HDC

ADMINISTRATIVE APPROVALS

April 01, 2026

RFI #6: OA & EA runs through the existing chimneys

① 04 - Roof
1/4" = 1'-0"

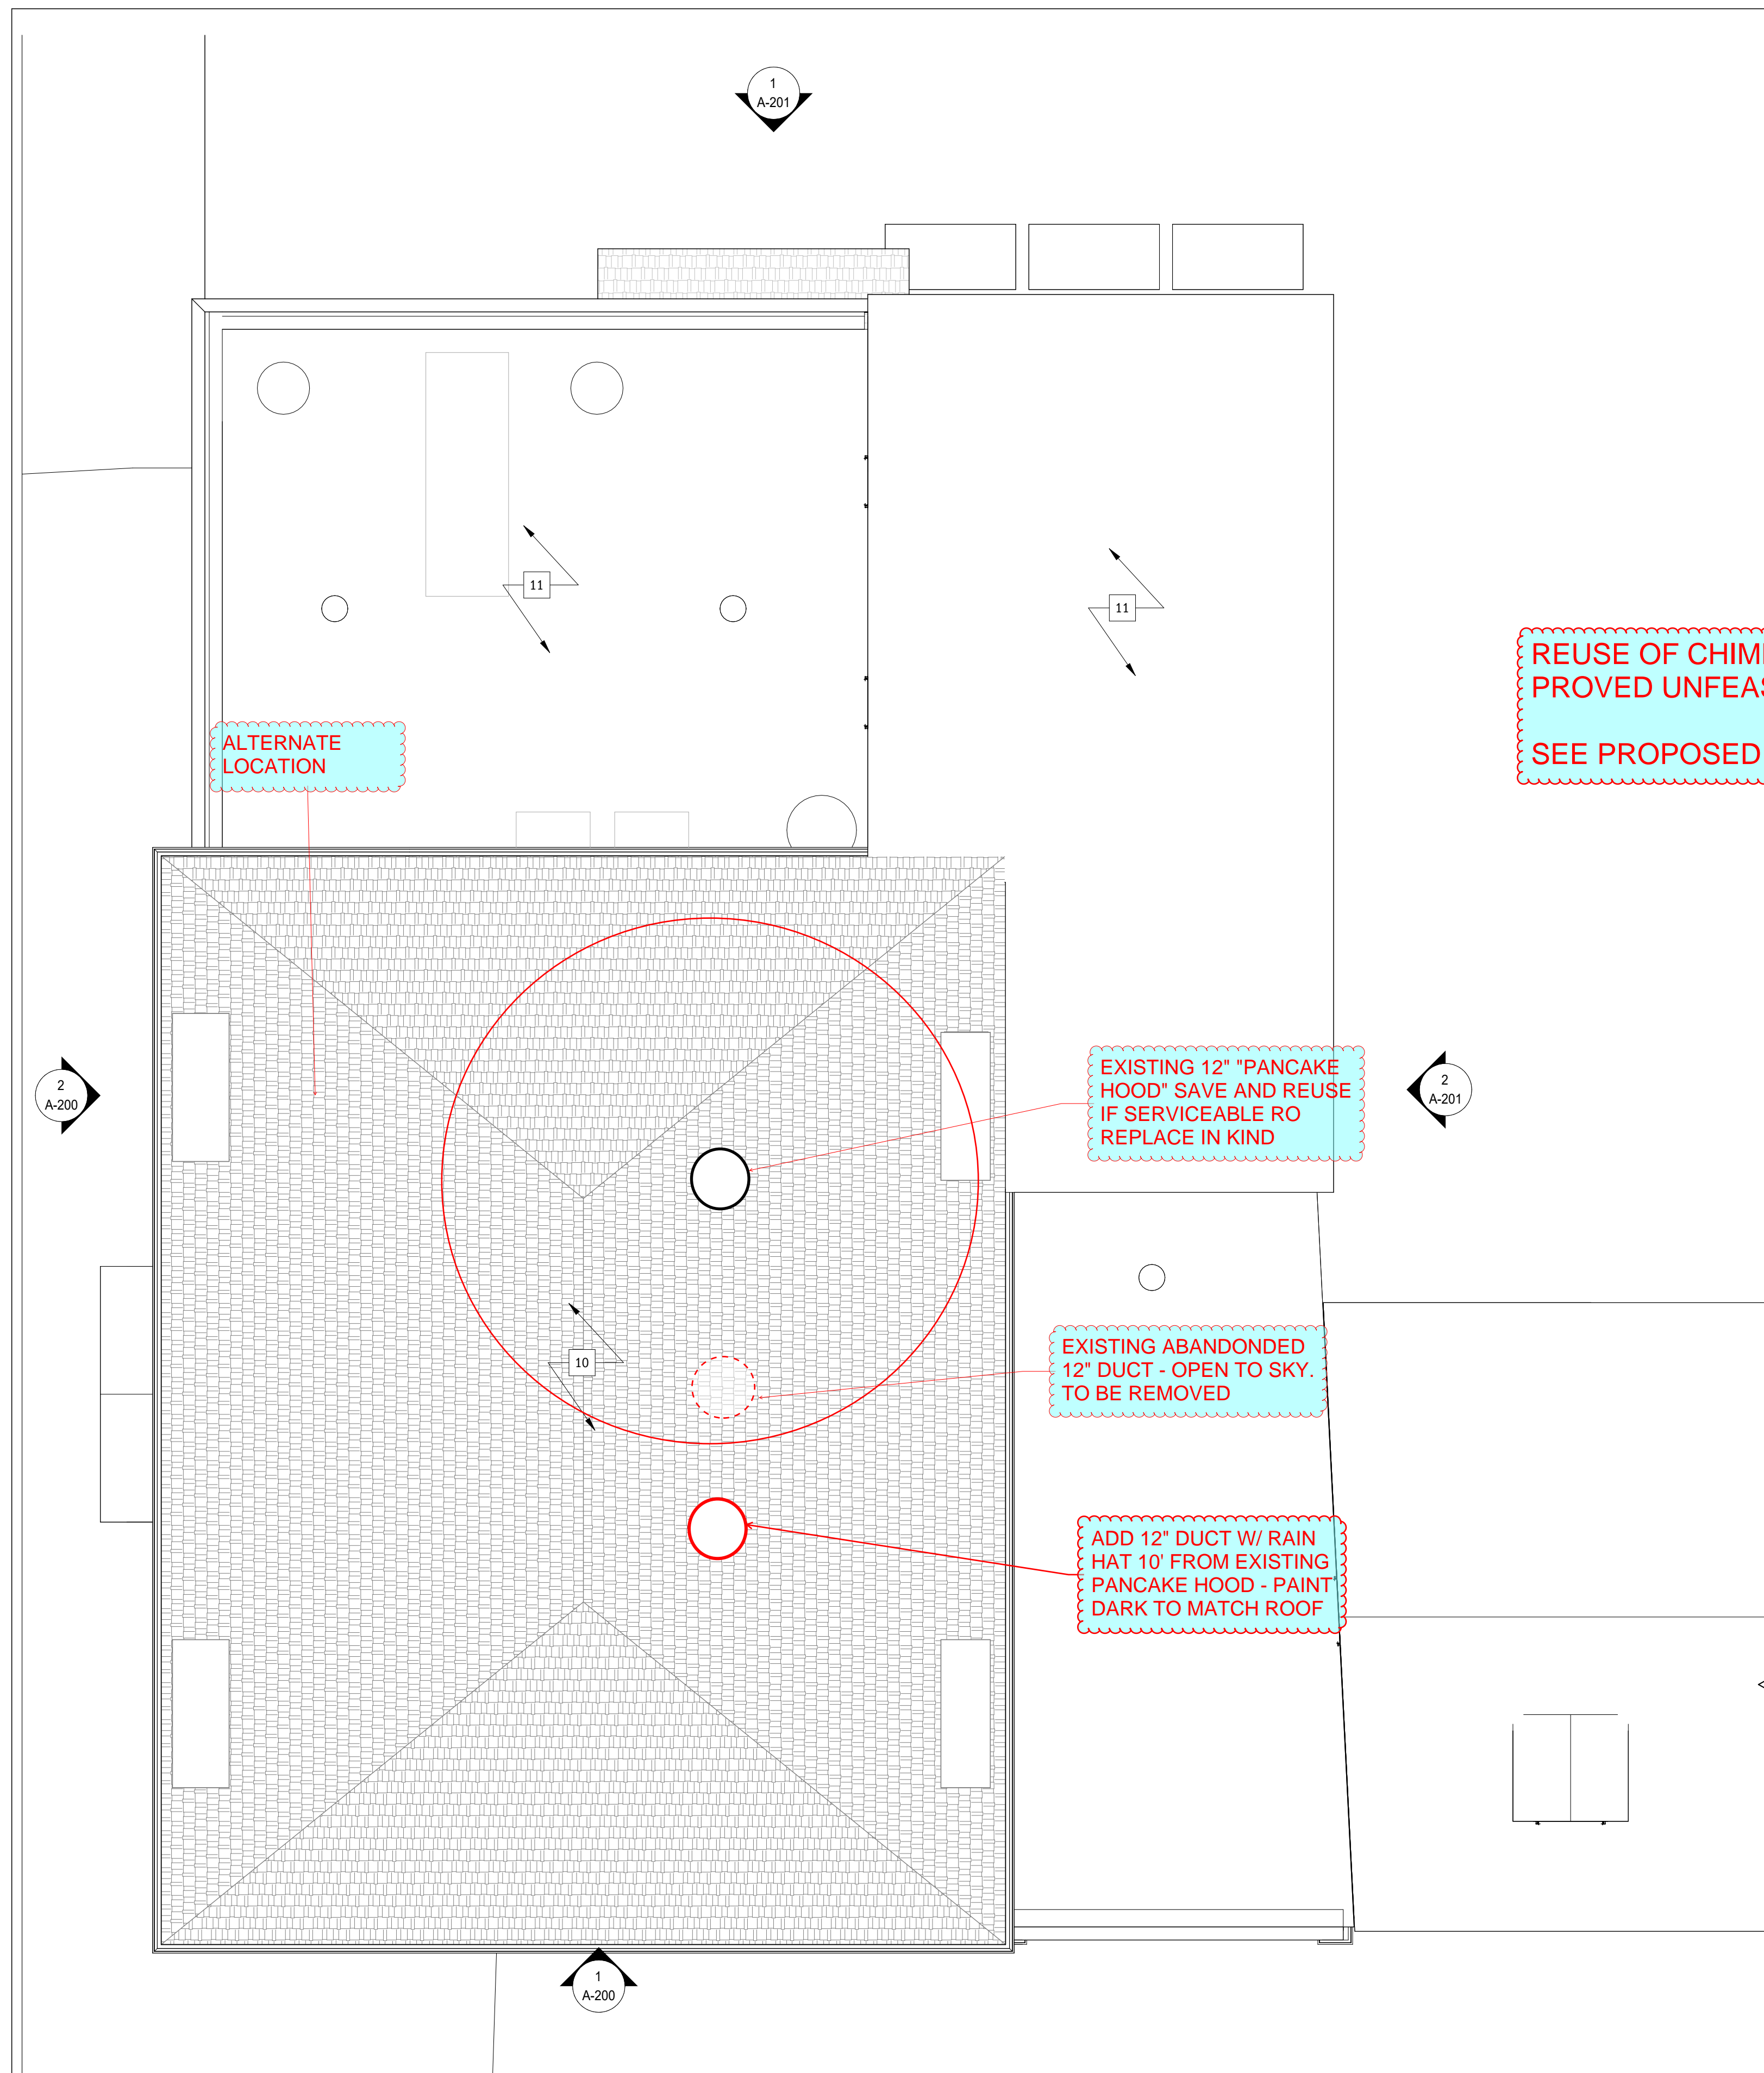
DWG H2.4 calls for 6" OA & EA runs through the existing chimneys.

Notes 1& 2 calls for chimney prep & coordinating with ARCH.

Notes on DWG H2.5 calls for capping the chimney.

- What are the OA vertical runs? 6" metal pipe?
- How do they penetrate the existing chimney?
- How do the runs get attached at the top of the chimney under the new cap? Do they stick up 2" and paint black so no visual impact? The Historical District would like to know prior to issuance of the MECH Permit.
- Please provide a detail for this chimney cap as well. Metal? Stone? Finish color, etc.

- APH and Martini were able to review the attic and roof penetration options for the ERV OA & EA on Thursday 2/26. It is our understanding that one 12" duct is needed for OA and one 12" duct is needed for EA and then both are branched over to the 3 attic ERVs.
- There exists a 12" attic roof duct into a pancake hood. This looks like it can be reused. Photos are below and plan drawing is attached.
- Near that pancake hood is an abandoned 12" duct that is open to the sky. Because this exists, we are only asking to R&R it and move it 10' (min) from the pancake head. New duct will be painted dark to match the new roof and have a low-profile rain cap on top.
- Attached are (4) photos and a marked up plan for your review.

Following our 2/24/2026 discussion, it was determined that chimney penetrations and utilizing the existing chimney flues for these (6) 6" pipes will not be feasible. We are looking for a route thru the building into the attic and penetrating the roof at (2) locations or utilize existing louvers for the current equipment that we could tie into.

This consists of a bank of (3) OA penetrations and another bank of (3) EA penetrations. See attached Snip of MECH DWG.

**REUSE OF CHIMNEYS FOR VENTING PROVED UNFEASIBLE.
SEE PROPOSED SOLUTION BELOW.**
